Addendum

SPRINGS AT FREMAUX TOWN CENTER
SLIDELL, LA

DRAWING TITLE FIRST FLOOR PLAN - CLUBHOUSE

SANITARY WASTE AND VENT RISER DIAGRAM - CLUBHOUSE
SCALE: SCHEMATIC ONLY

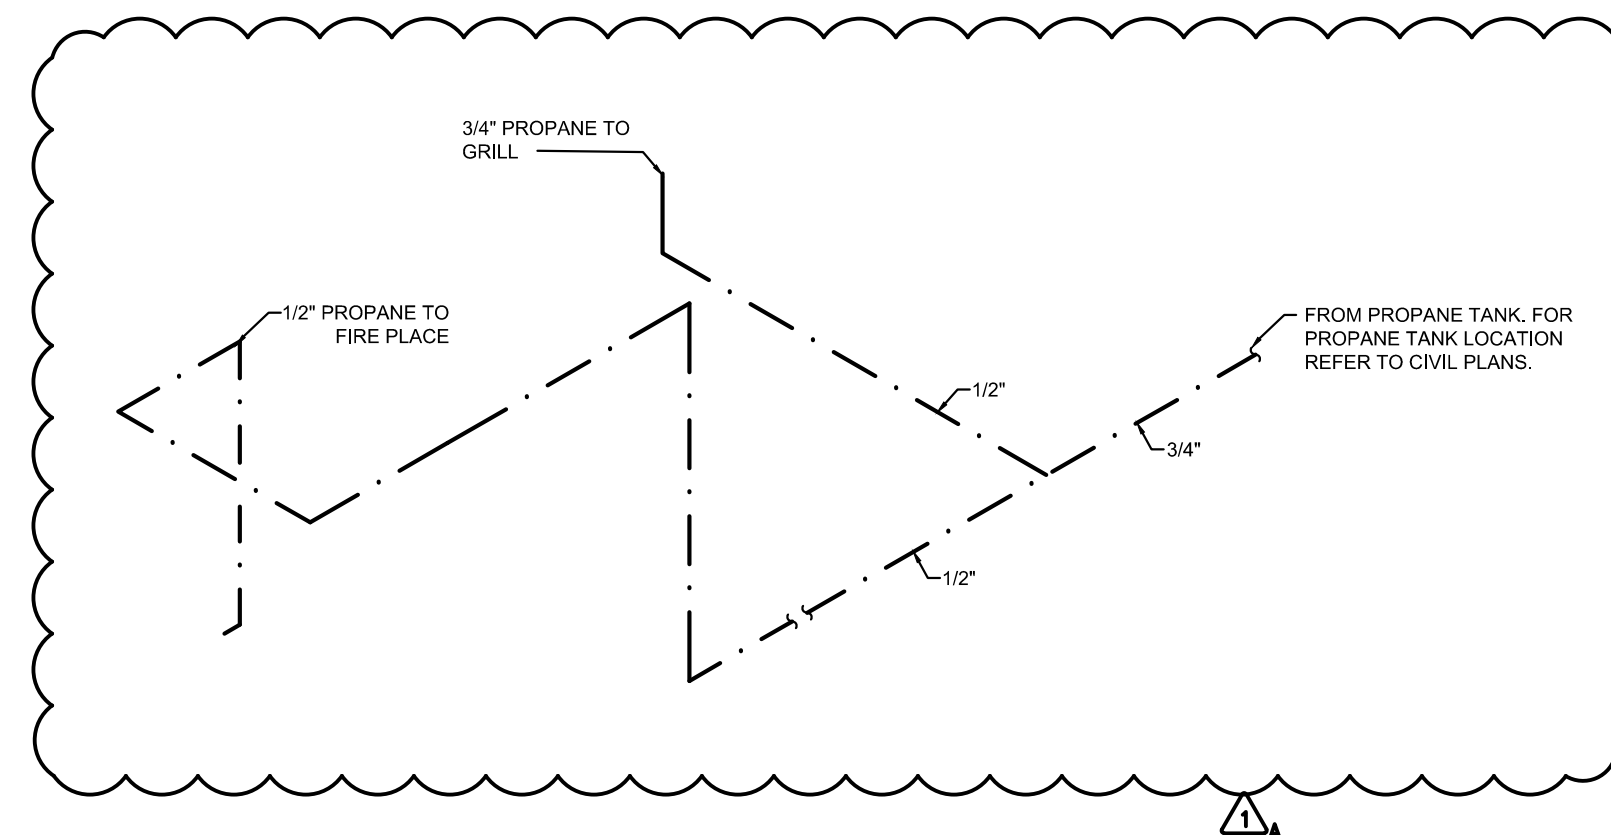
- A. REVISED GAS LINES FOR PROPANE
- B. REVISED PLUMBING PER REVISED BASE PLAN
- C. ADDED WATER LINE FOR FUTURE BOTTLELESS WATER COOLER

① FIRST FLOOR MECHANICAL PLAN - CLUBHOUSE
SCALE: 1/4"=1'-0"

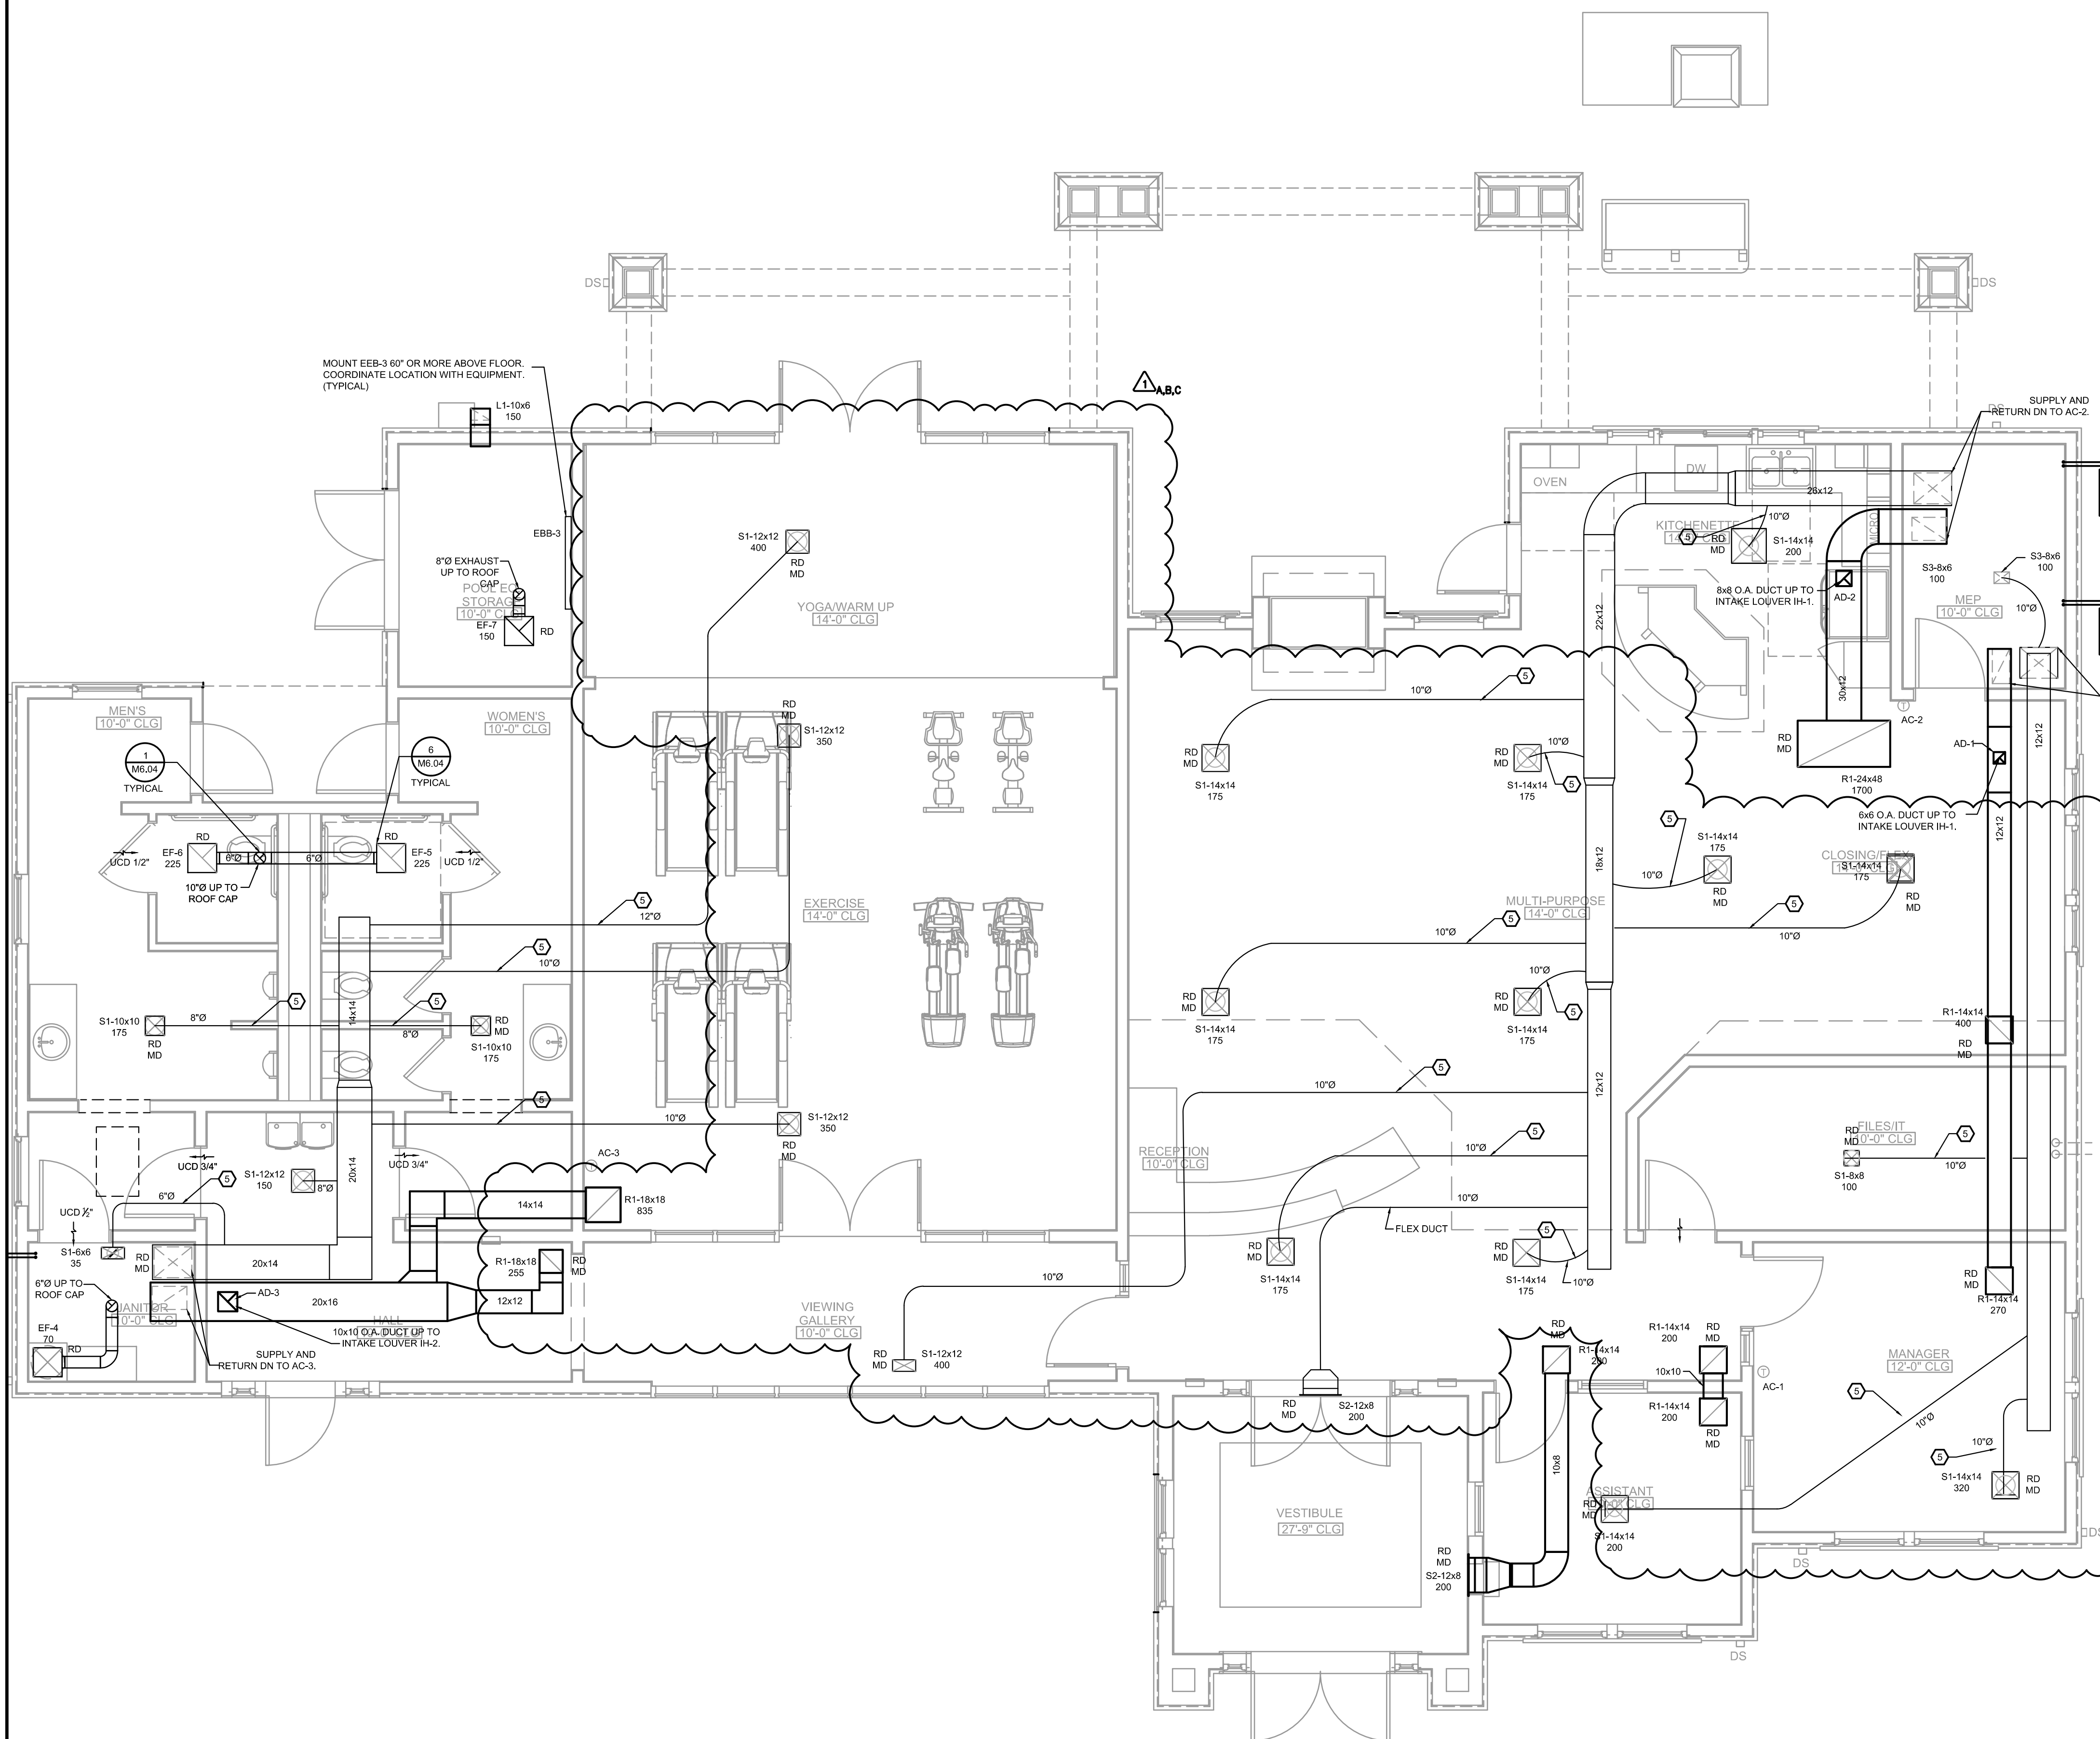
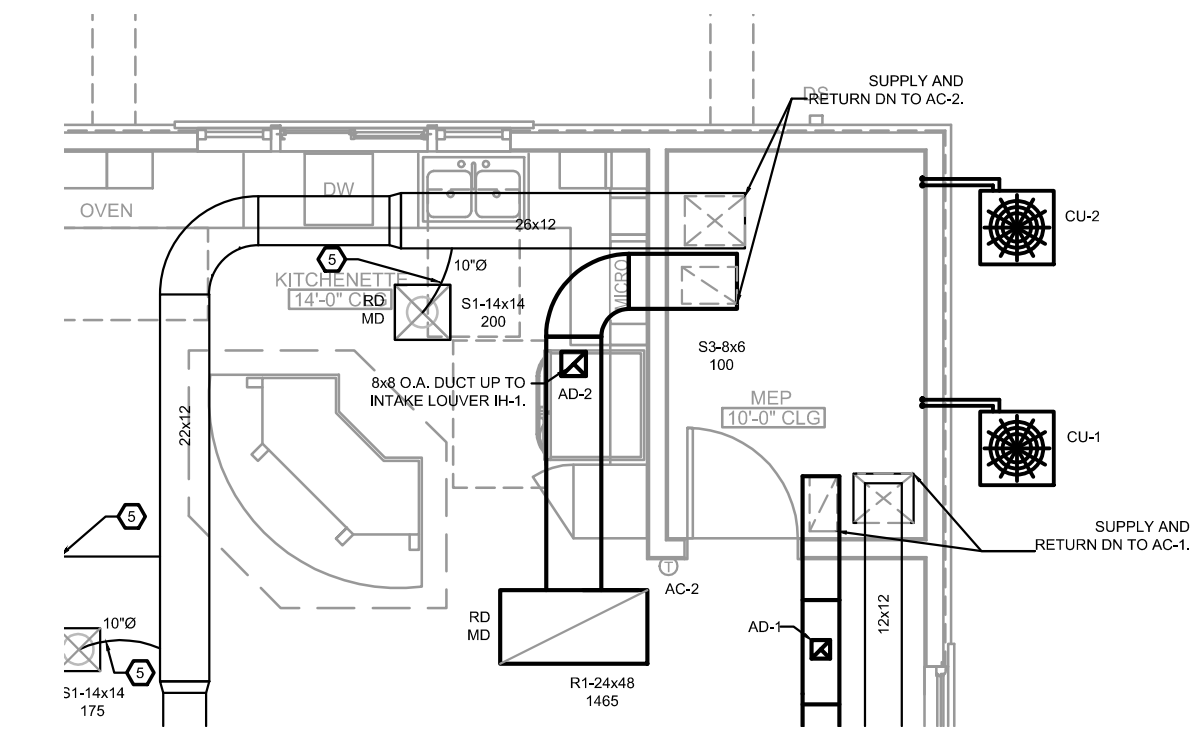
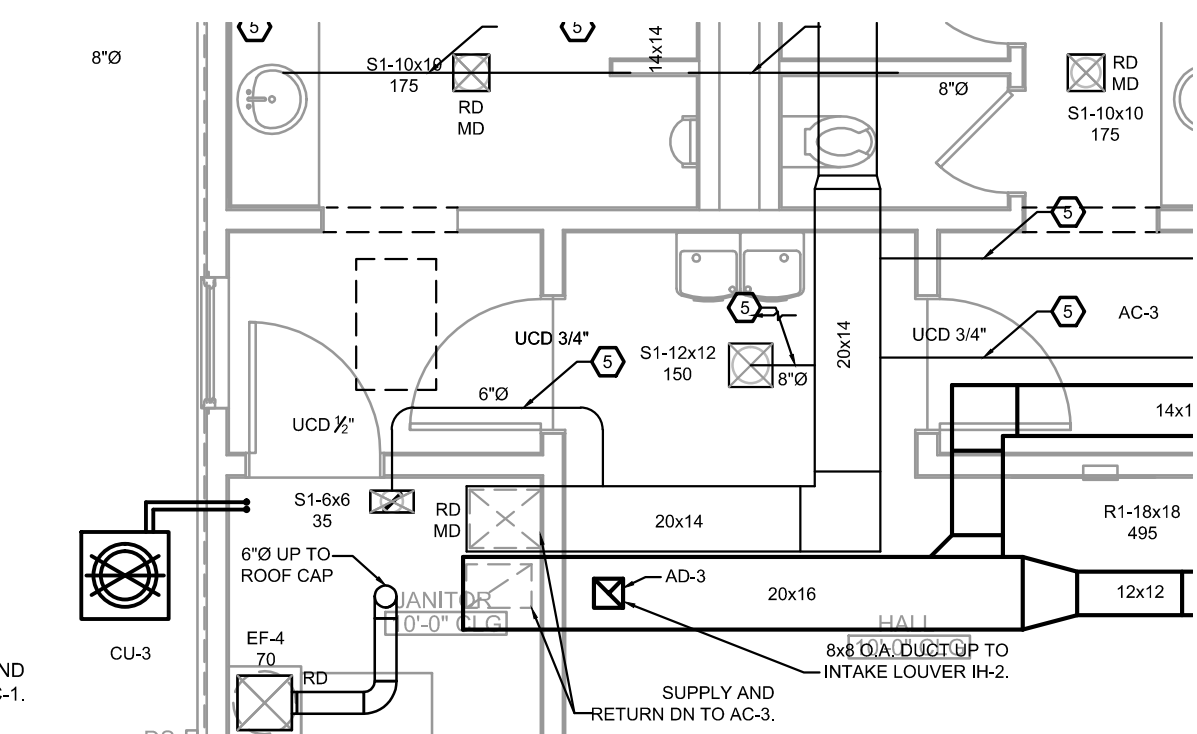
REVISION #1 SUMMARY	
A.	DUCTWORK CORRECTION.
B.	REVISED BASE PLAN.
C.	REMOVED EXHAUST FAN.
D.	ADJUST NORTH ARROW
